SERVICE BULLETIN

M-911

JIFFY STAND CATCHES — XLH MODELS

Figure 1. Jiffy Stand

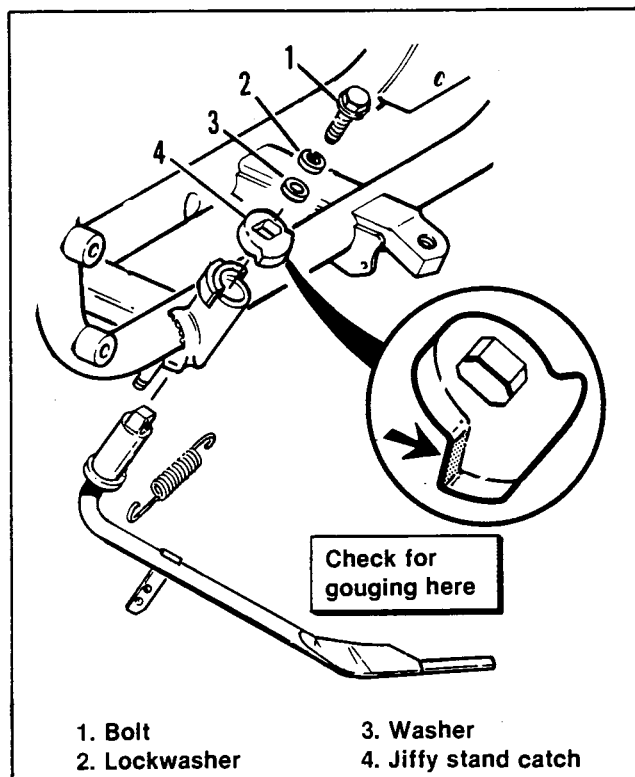
Our records indicate that some 1986 XLH model motorcycles may have been assembled with "soft" jiffy stand catches. The "soft" metal condition may allow the square on the jiffy stand to rotate in the catch and allow the motorcycle to tip.

See Figure 1. Inspect all motorcycles at your dealership and those you have sold that are in the VIN range listed above for excessive lean angle while resting on jiffy stand. Also examine the leading edge on the catch that contacts the frame.

Any gouging or metal displacement at this location indicates the catch is soft and must be replaced. Order Harley-Davidson Part No. 50038-84.

1. See Figure 1. Support motorcycle and remove bolt (1), lockwasher (2) and washer (3).
2. Remove catch (4) and replace with properly hardened catch, Harley-Davidson Part No. 50038-84.
3. Install hardware removed in step 1 and tighten bolt (1) to 18-20 ft-lbs torque.
